TOWN OF PLATTSBURGH
BATTLEFIELD MEMORIAL GATEWAY PHASE 2
AES PROJECT NO. 5314

ADDENDUM NUMBER 3

DATE: May 12th, 2025

PROJECT: Battlefield Memorial Gateway Phase 2

CHANGES TO THE PROJECT DRAWINGS		
Item #	Drawing	Change
01	C-101 Site Plan	DELETE: C-101 Site Plan dated 4/14/2025 - In its Entirety INSERT: C-101 Site Plan Addendum No. 3 dated 5/12/2025

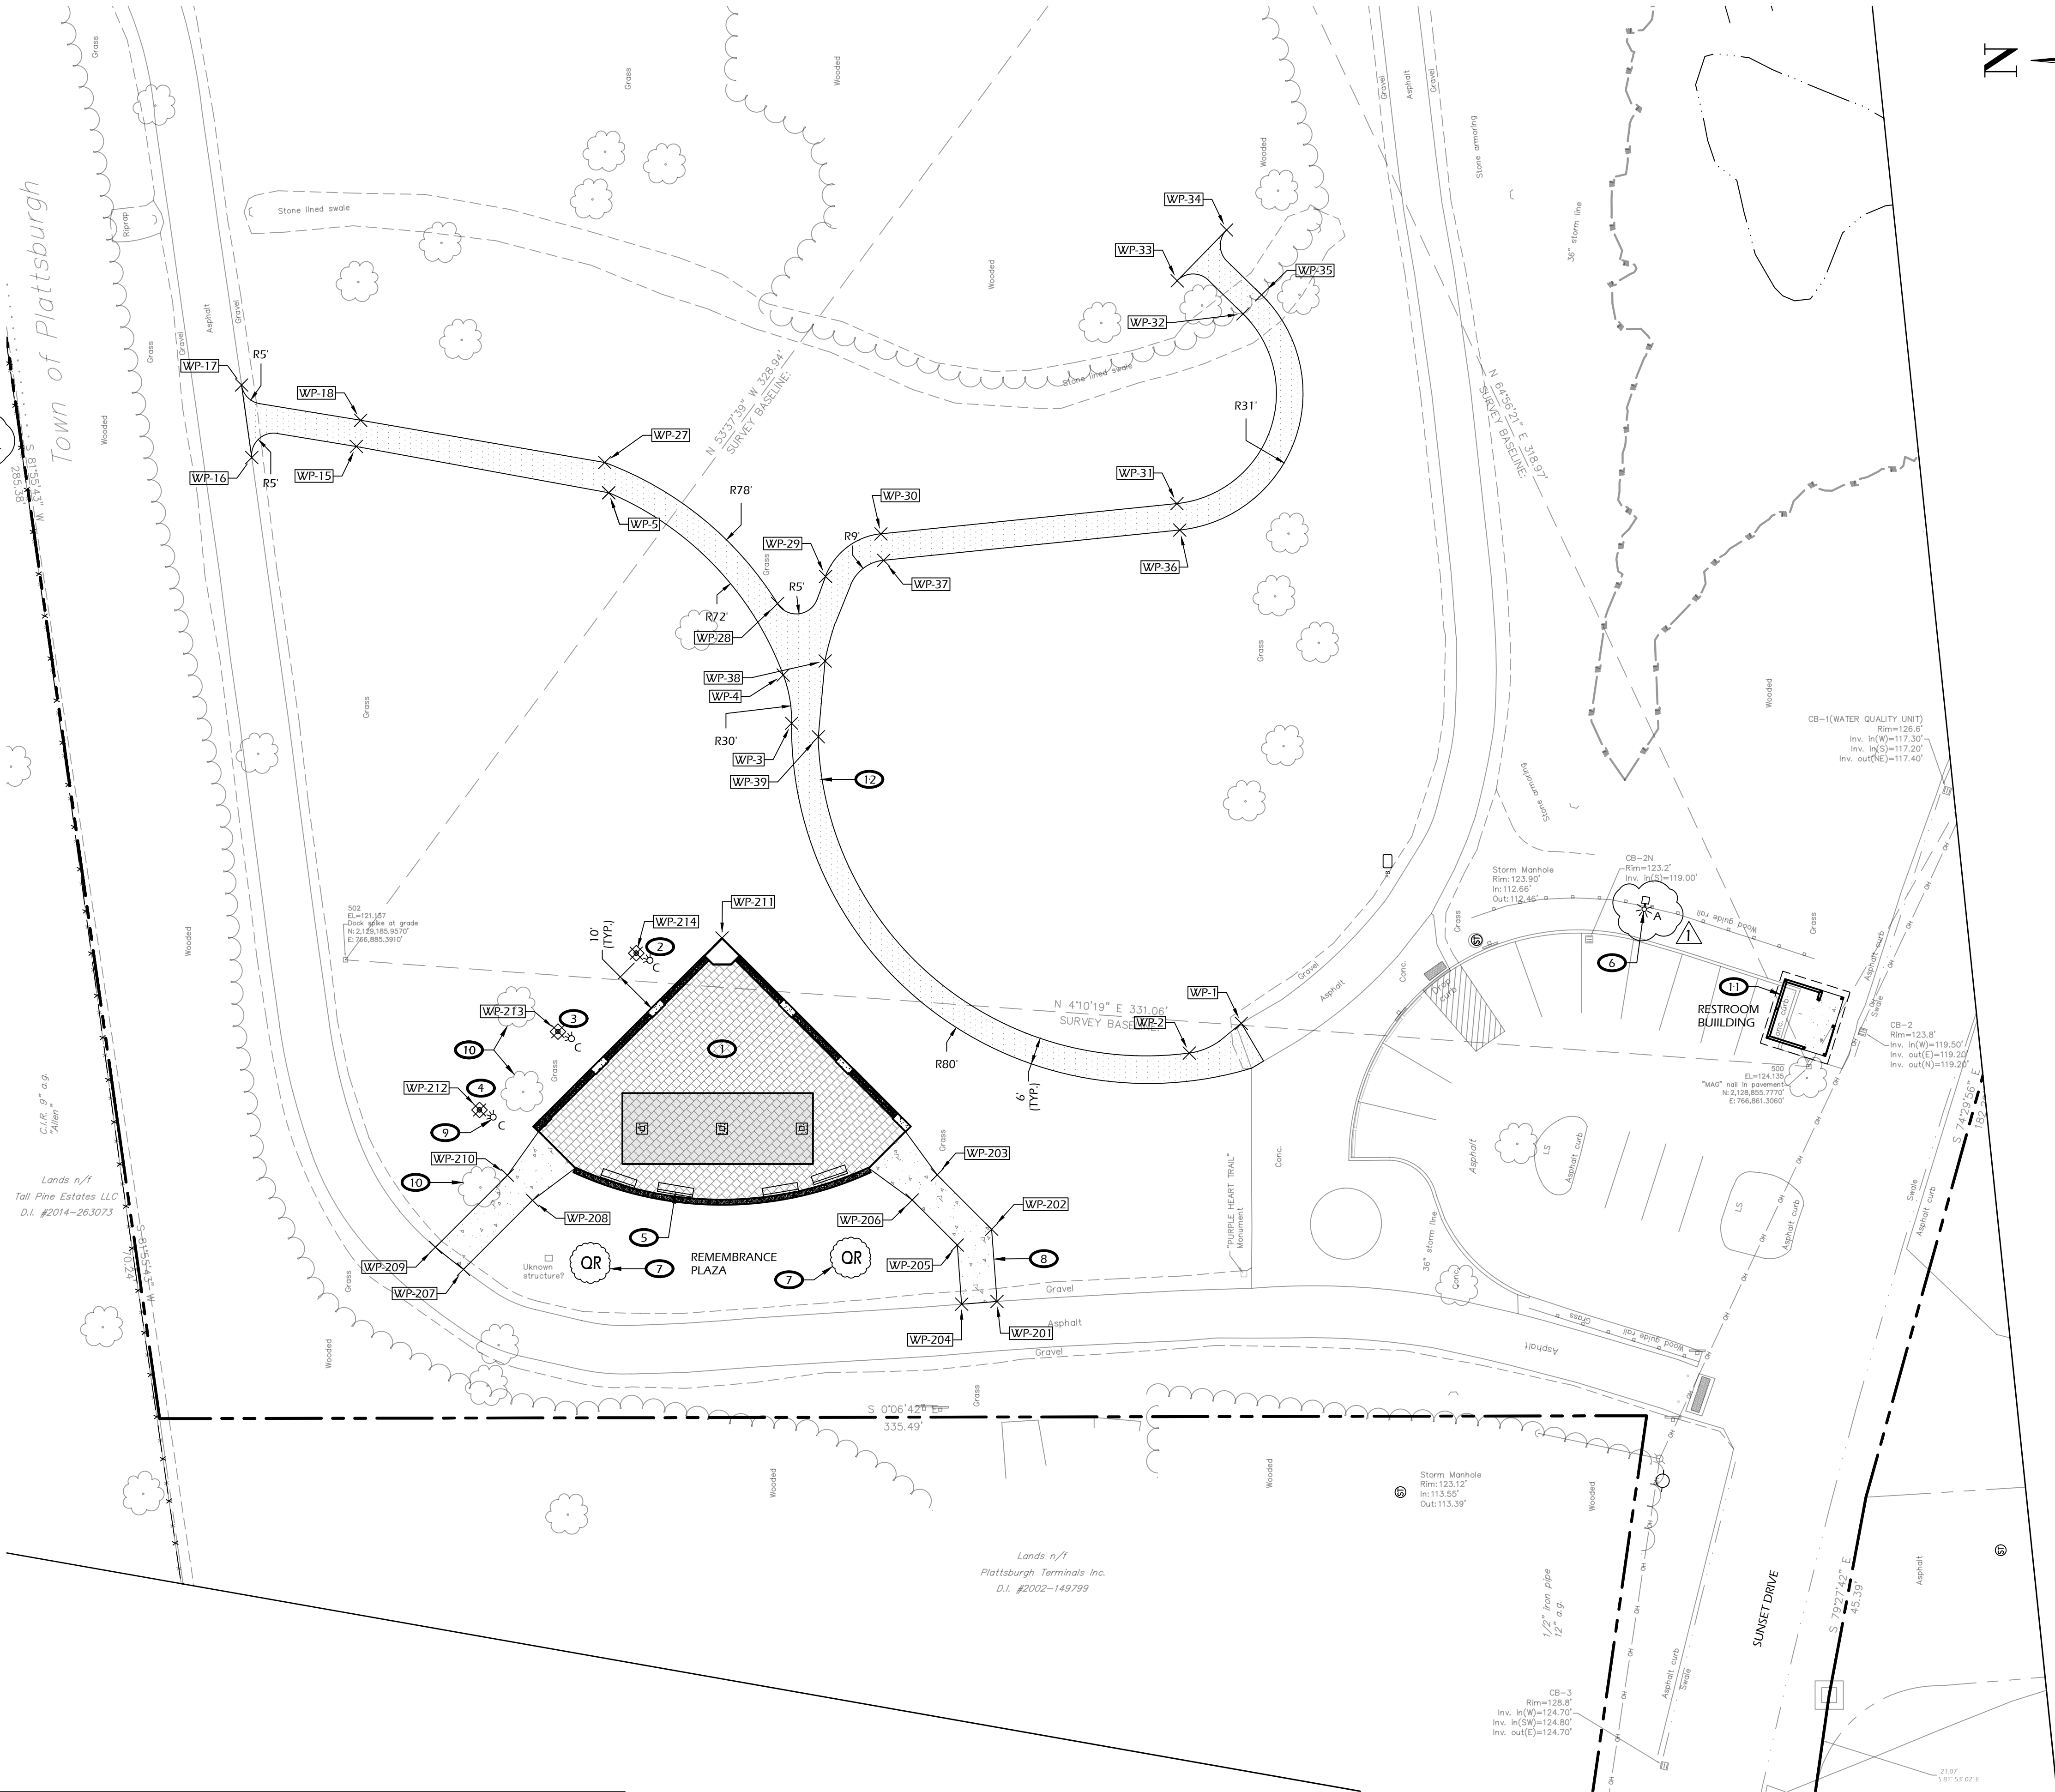
REQUESTS FOR CLARIFICATION	
RFC: Dow Electric, Inc. dated 5/8/2025 (attached)	
Question: <i>There is no D fixture on lighting schedule.</i>	
Answer: “D” Tag light fixture shown on C-101 has been updated to “A”.
